P-3 Air Flow Multiplier Upgrade

P/N: 2215790-1-1

New Design vs. Old Design

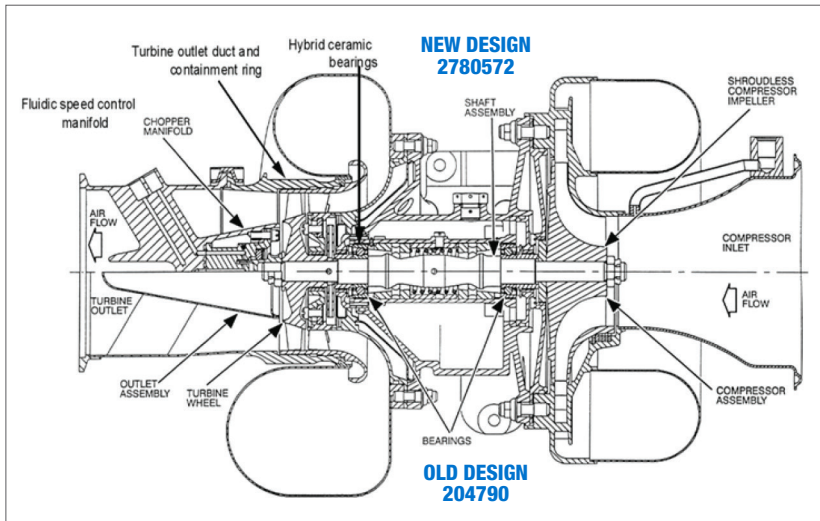
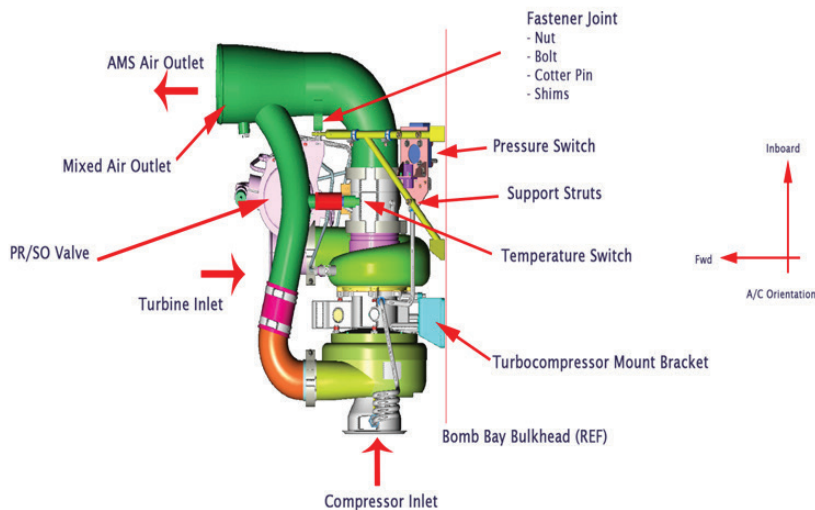
Critical Issues

- » Over-speed
- » Shroud joint fatigue
- » Thin outlet wall
- » Bearing failure
- » Low MTBF

- » Increased Reliability:
 - Ceramic hybrid bearings used in turbo-compressor
 - Upgraded pressure regulator controls
 - Increased mission effectiveness and improved avionics life
- » Improved Safety:
 - Prevention of AMS over-speed thru fluidic control
 - Improved turbine wheel containment
- » AMS Speed Within A Narrow Band:
 - Incorporation of periodic functional testing of the thermal & pressure switches
- » Drop-In Replacement:
 - Installation into P-3 models without airframe or duct modification (except P-3C update III aircraft)
